MYO MONITORING REPORT

Swamp Grape Stream and Wetland Mitigation Site

Response to DMS Comments – Draft Baseline Document (MY0) and As-built Drawings
DMS Project No. 100115
Full Delivery Contract No. 7869
DMS RFP No. 16-007705
USACE Action ID No. SAW-2019-00904
DWR Project No. 2019-0675

Comments Received (Black Text) & Responses (Blue Text)

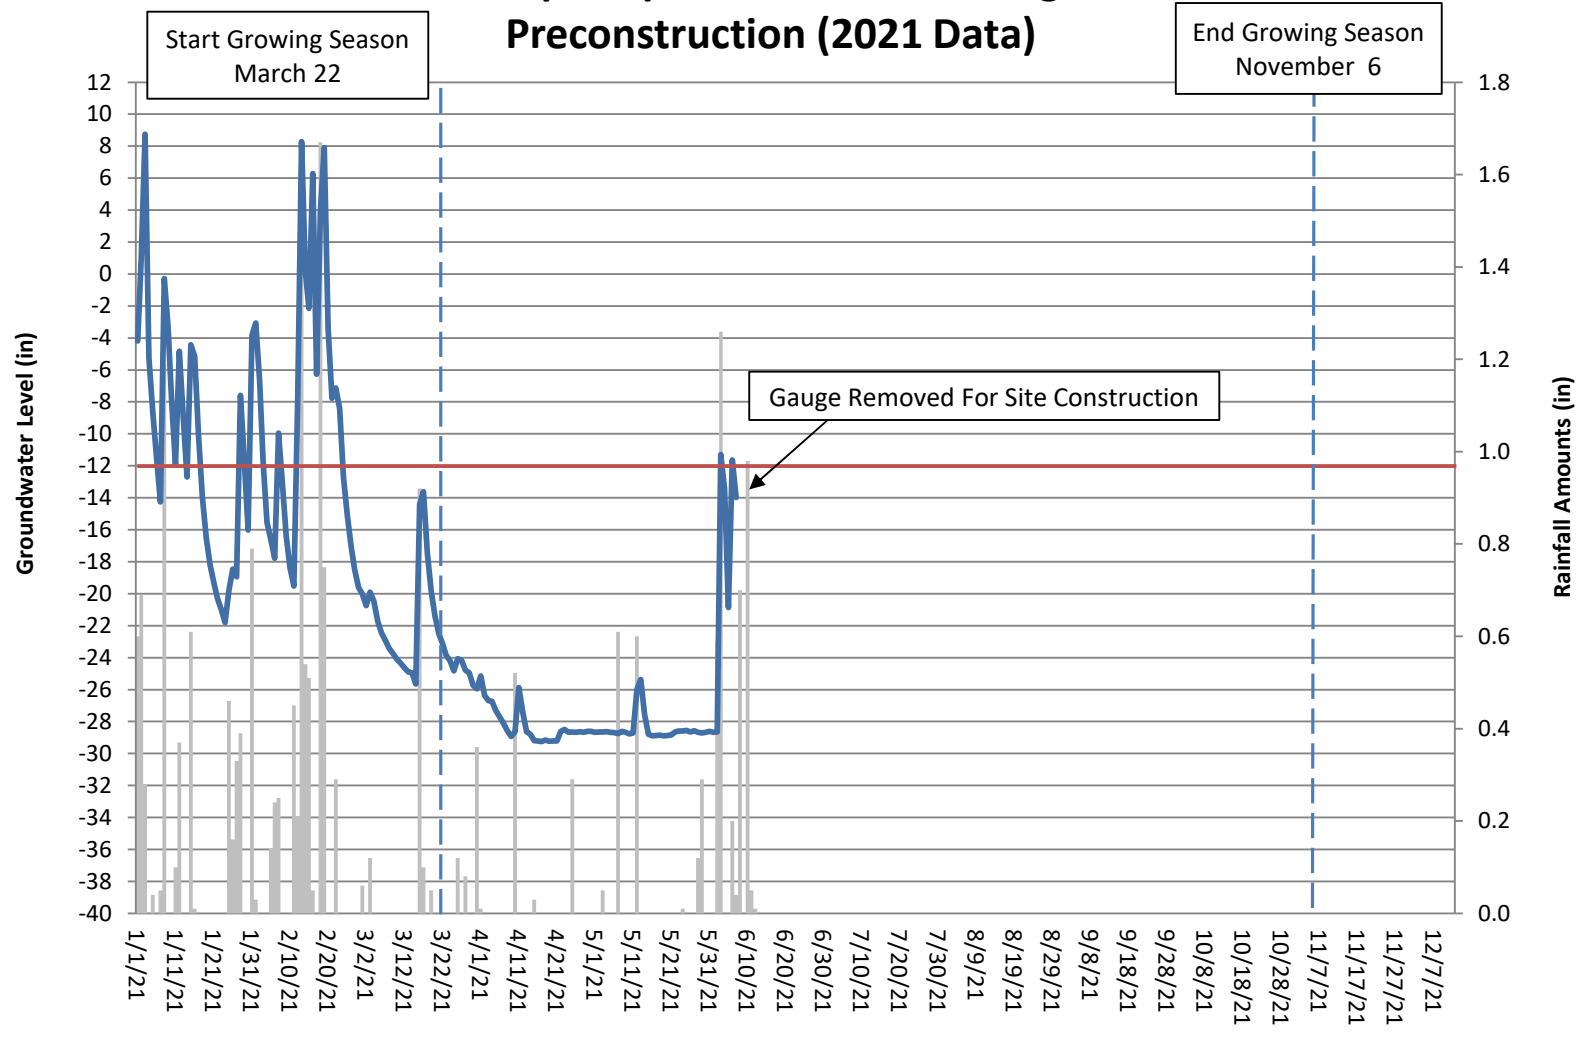
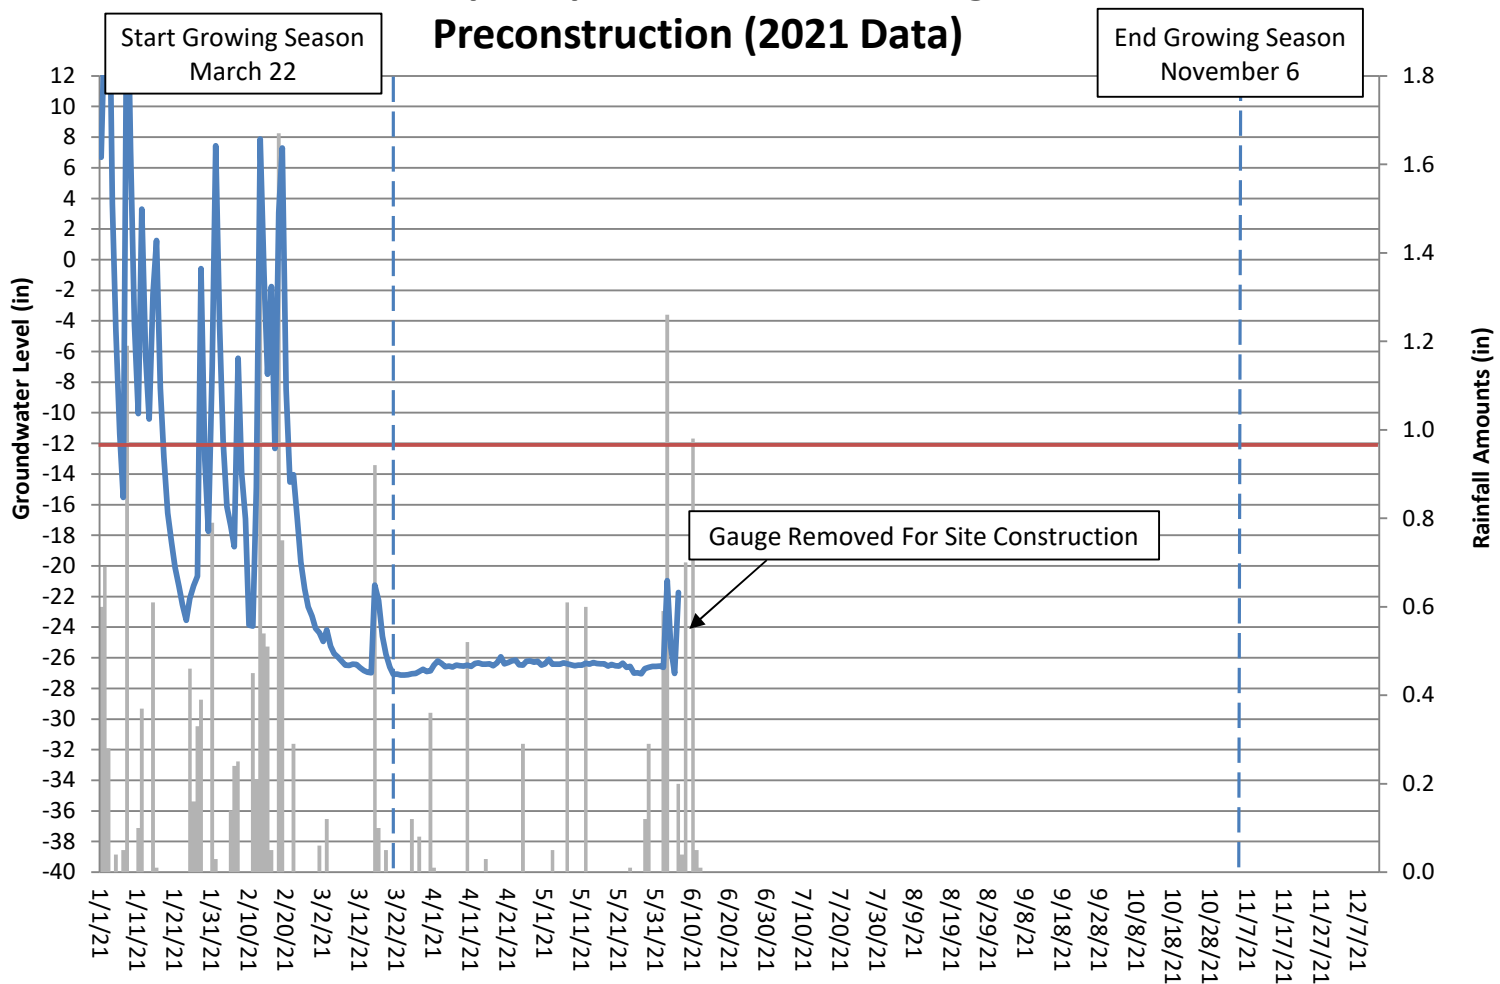
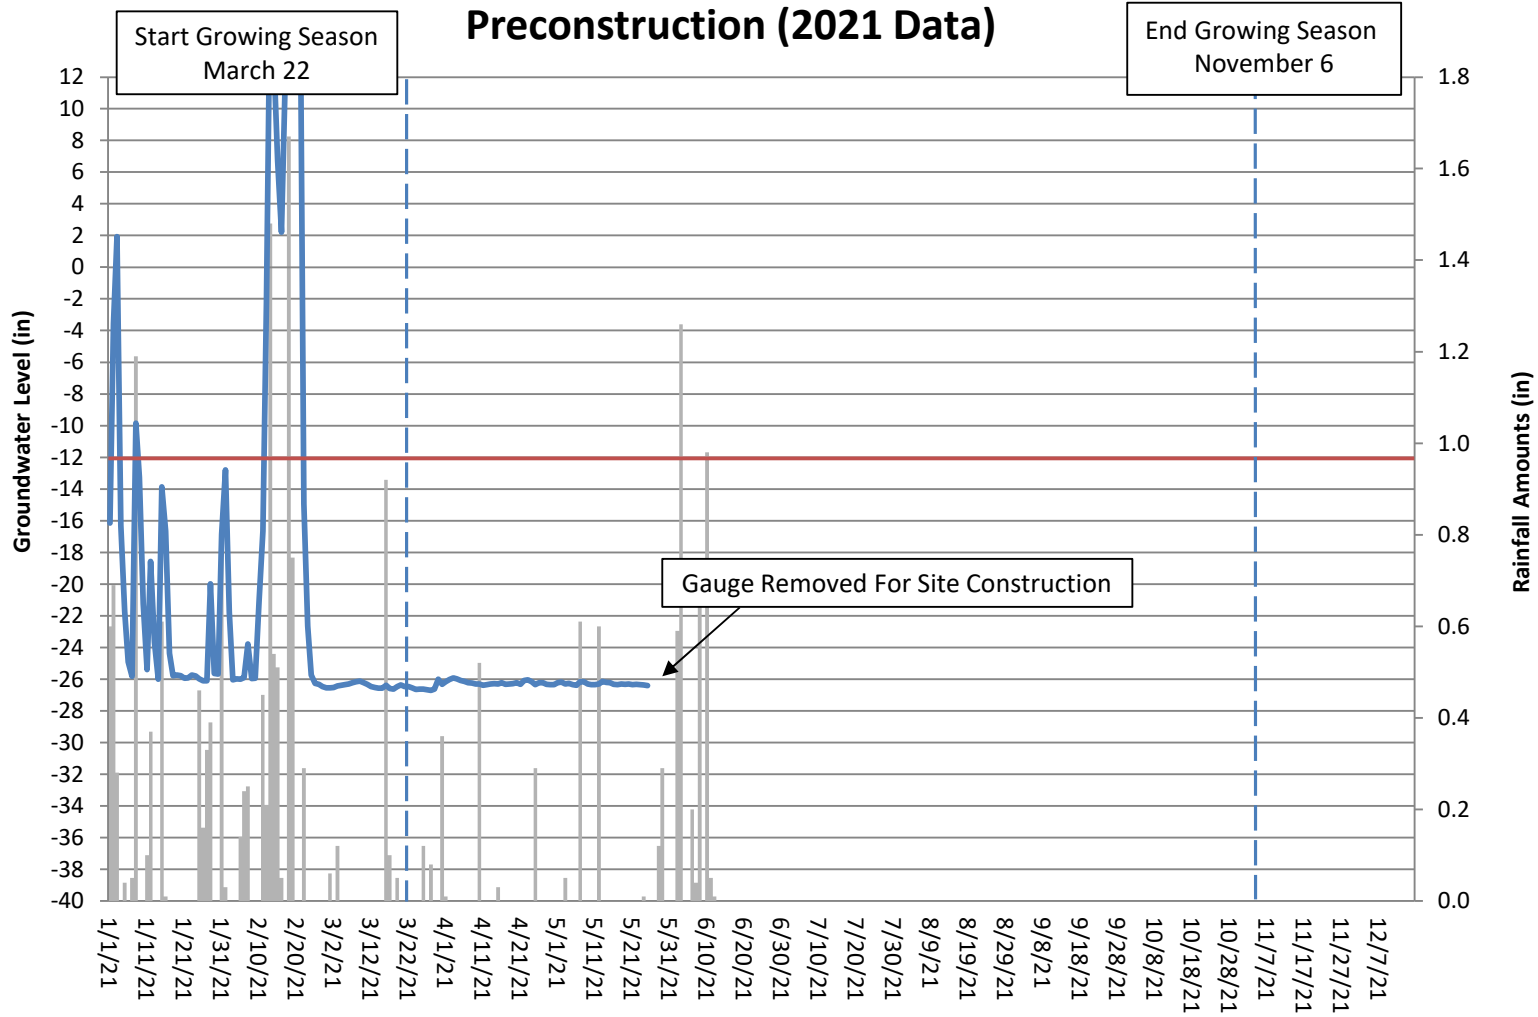
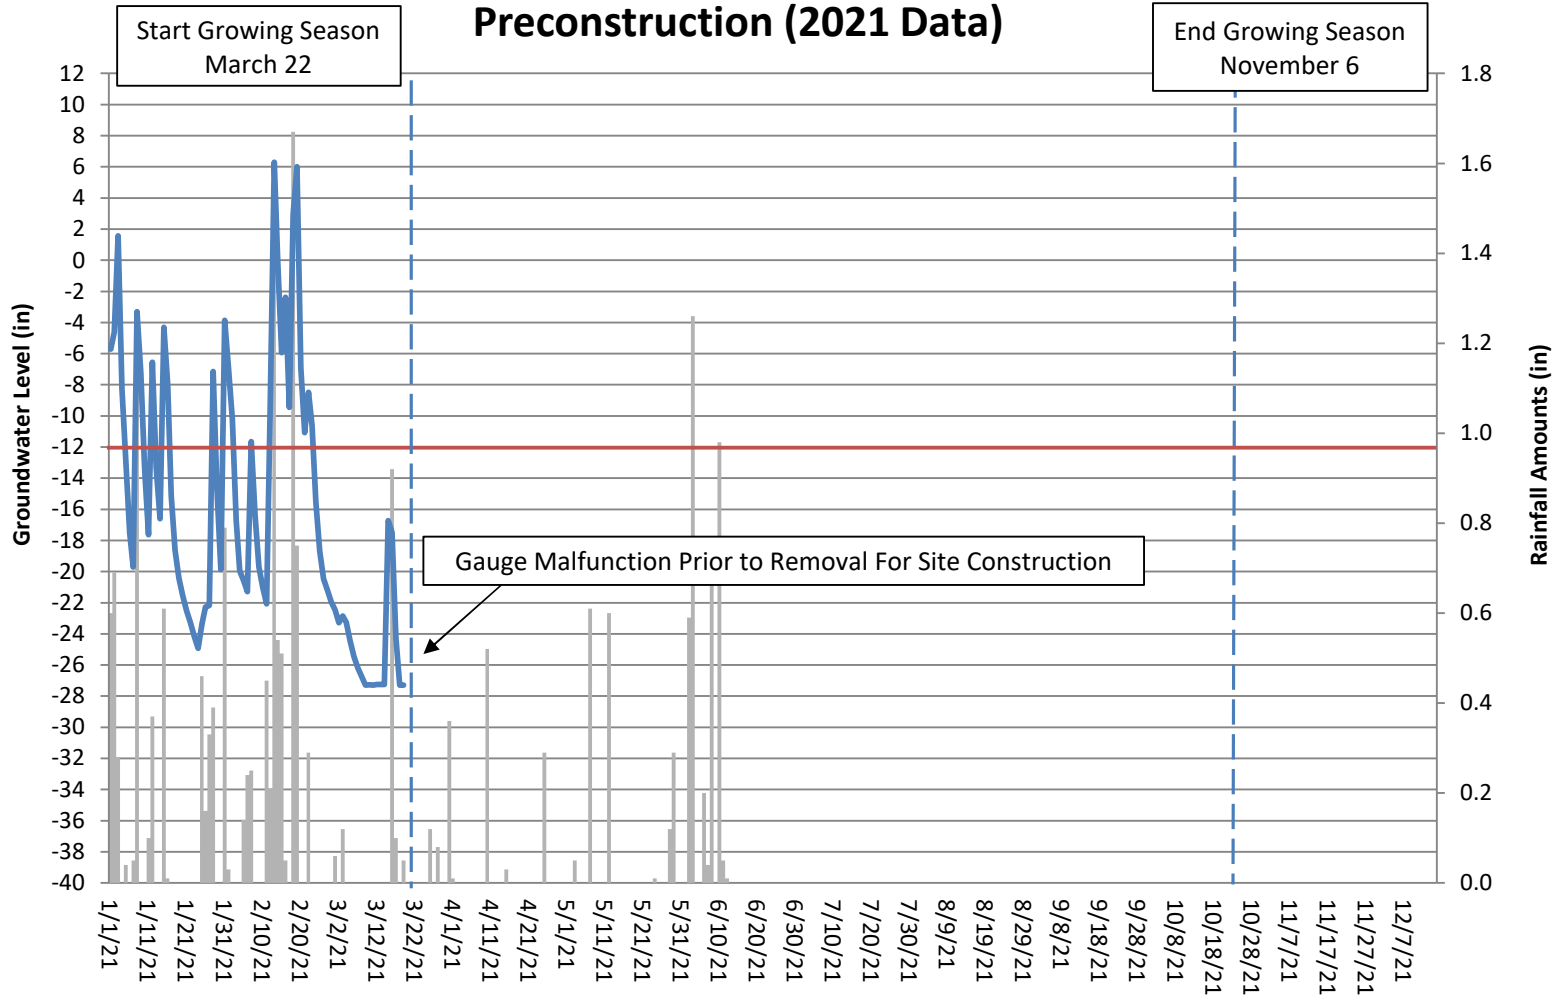
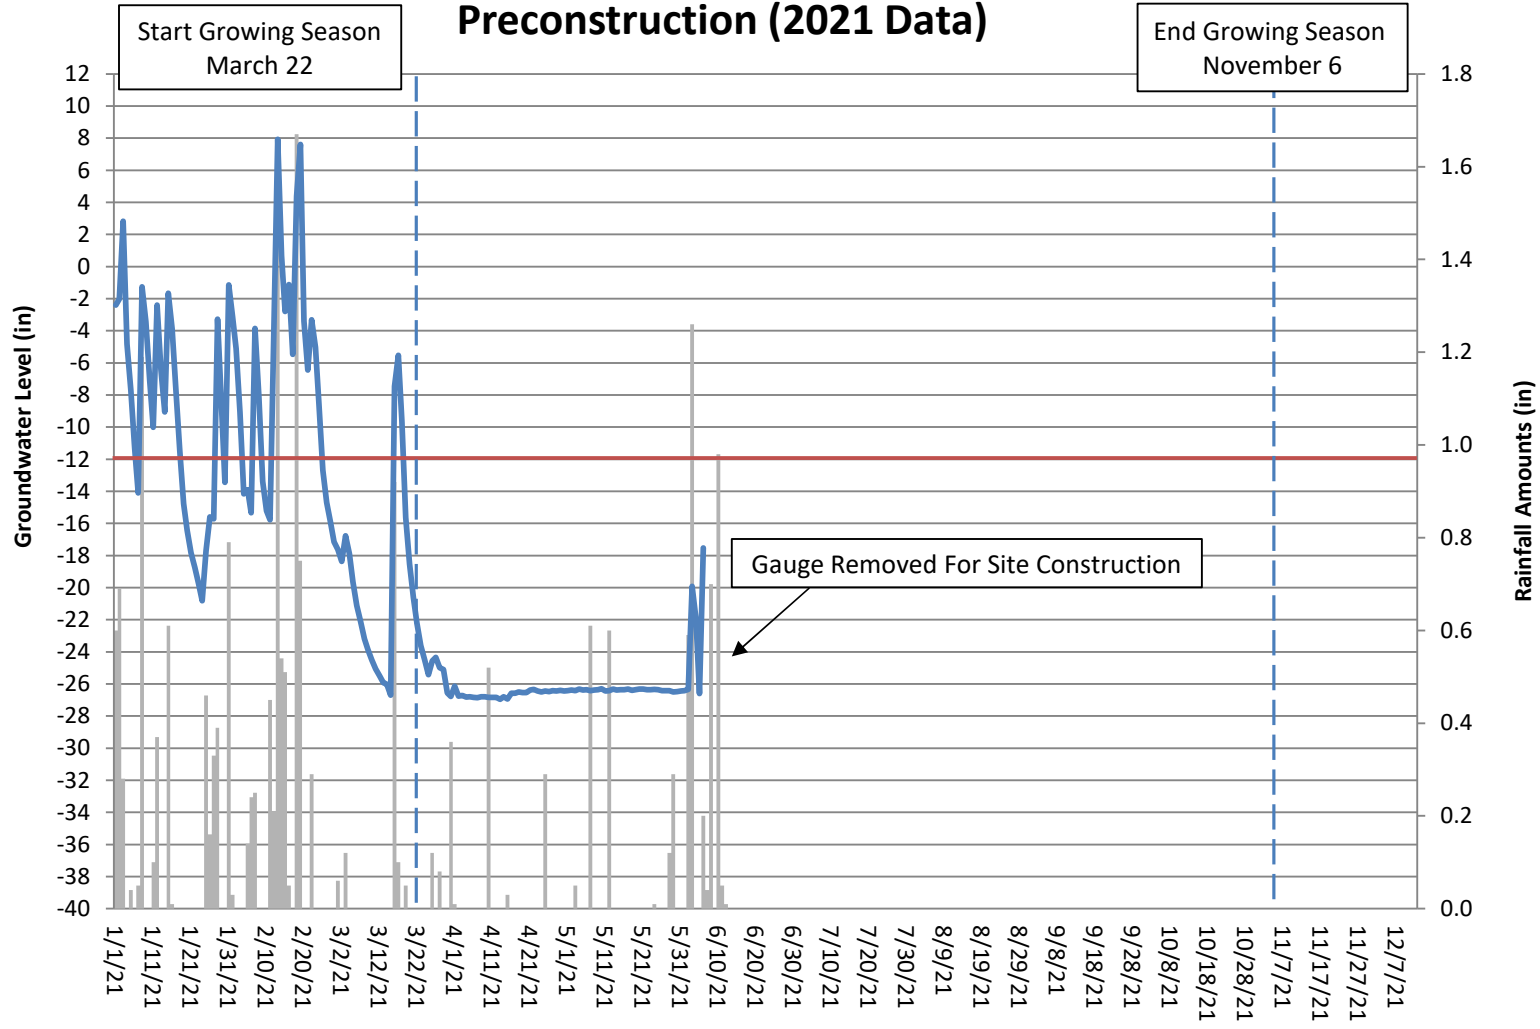
1. Cover pages: check USACE ID no; DMS has 2019-00904 in its records.
Response: The USACE ID was corrected to 2019-00904.
2. Present the 2021 pre-restoration groundwater gage data in the MY0 report.

Response: We have included the 2020 and 2021 pre-construction groundwater gauge data in Appendix D.
3. In the field, we discussed that the pre-restoration gages numbers were not the same as post-restoration gage numbers. Provide a map of the pre-restoration gage locations and numbers. It may be useful to provide a discussion of the 2020 and 2021 data for context.
